PARKS & RECREATION COMMISSION STAFF REPORT

TITLE:	Aubrey Davis Park Trail Safety Improvement Project 30% Design Revisions	<input type="checkbox"/> Discussion Only
RECOMMENDED ACTION:	Approve revised 30% design; Approve transmittal memo to City Council	<input checked="" type="checkbox"/> Action Needed: <input checked="" type="checkbox"/> Motion <input type="checkbox"/> Ordinance <input type="checkbox"/> Resolution

1. Roundabout details

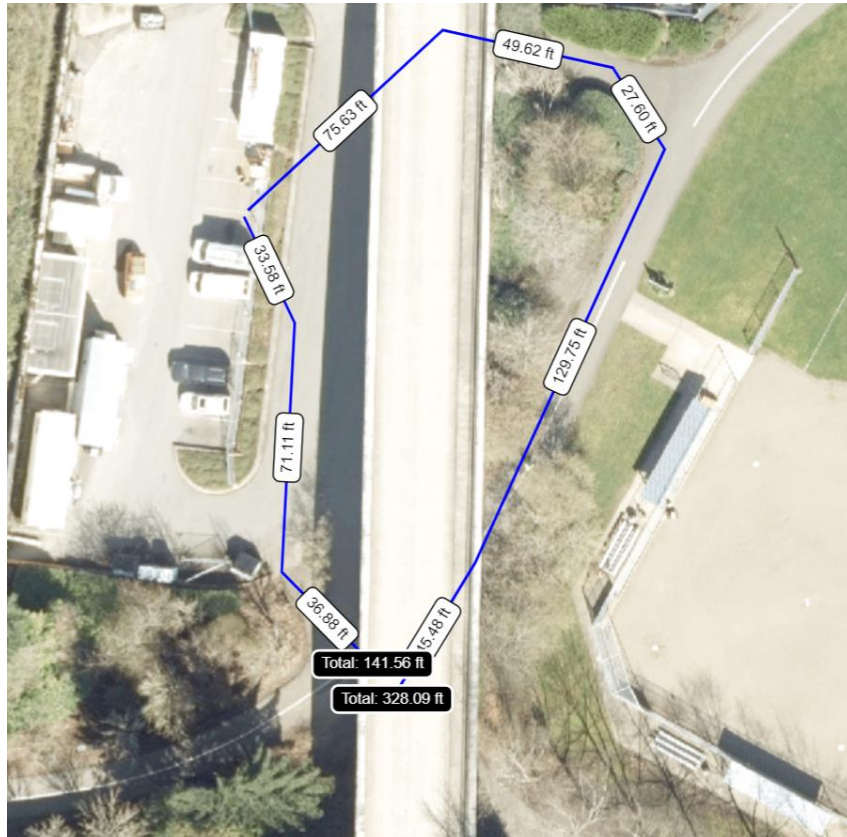
At the July 7 meeting, there was significant discussion of the details of the roundabout. The radius of the center island, the height and profile of the curb, and warning markings and signs were discussed. The Design Team confirmed its opinion that the roundabout is a way to improve circulation through the intersection. Subsequently to the meeting, the PRC received email comment (See Exhibit 2). The concerns included the poor lighting in the roundabout location, the limited sight-distance for trail users coming into the roundabout, the potential for slippery surfaces created by thermoplastic surfacing, the trail width in the roundabout, and the need to separate pedestrians from bicycles in the roundabout.

- The roundabout concept was discussed with Brian Walsh, WSDOT State Traffic Design Engineer, and there was general support that the City was considering a bicycle / pedestrian treatment for this regional facility. He discussed a similar application in Thurston County that was very well received by the regional trail users along the Chehalis Western Trail. WSDOT is supportive of treatment that intends to provide safer facilities. All treatments are evaluated for contextual application and this roundabout, based on his experience, is a context that WSDOT would support.

- The rolled curbing design has not been finalized, but it is envisioned to be a low-height, ramped curb that is traversable by wheeled vehicles. There is more study needed by the Design Team to ensure the roundabout will not be a hazard for cyclists and pedestrians.

- Lighting can be added to the roundabout intersection. Again, more study is needed by the Design Team regarding this potential element. At the least, power conduit could be installed to allow the option for lighting in a future phase of work.

- Separation of pedestrians and cyclists is not realistic in this location. Eight feet is standard width for a one-way split trail, however we can recommend widening the one-way trail to ten feet where we might expect bikes to encounter ped flow from the opposite direction.

- The roundabout examples sent with the August 12 email are not comparable to the Aubrey Davis Park Trail, except for the Wisconsin example. Most are college campus facilities with high volumes of bike ridership at peak times (class change). They are designed to accommodate maintenance and security vehicles and are therefore much wider.

- There are a variety of thermoplastic products on the market, some of which are specifically designed for bike applications to provide traction under wet weather conditions. The Design Team will investigate this issue in future phases of design. It understands that the PRC's objective is to end up with a surface that has adequate traction for trail users under the anticipated range of conditions on the trail.
